REMARKS

App. No. 09/698,824 Amendment dated June 17, 2004 Reply to Final Office Action of 12/18/2003

FIG. 13B

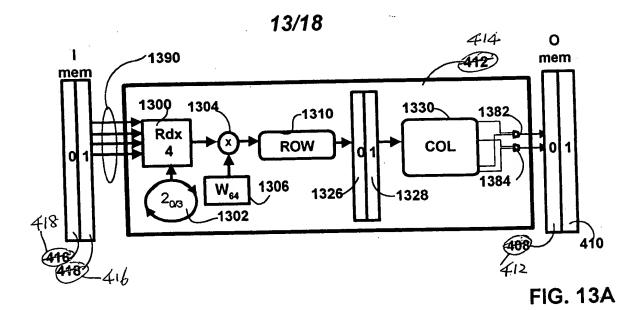
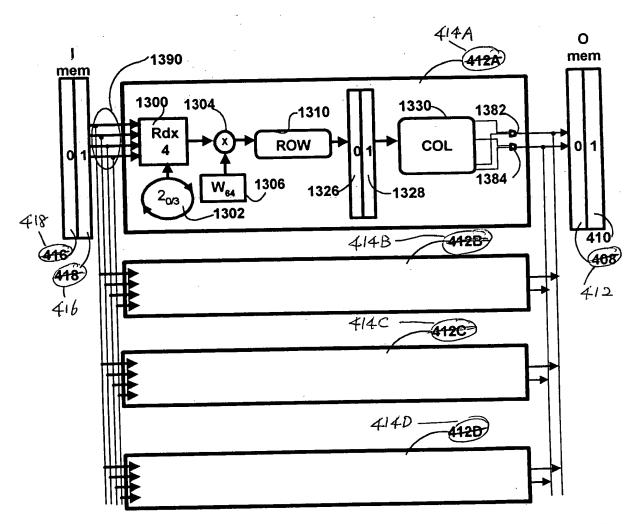
Applicant has amended FIG. 12B and FIGS. 13A-D. In the amended sheet FIG. 12B distinct reference numbers 1262-1264 have been given to the column transforms, replacing the former reference numbers 1252-1254. In FIGS. 13A-D the reference number used to reference the row and column transform component, and the reference numbers used to reference the input and output memories coupled thereto, have been amended to correct

obvious inconsistencies between the reference numbers used to refer to these components in the subject figures and in FIG. 4 in which they were initially introduced.
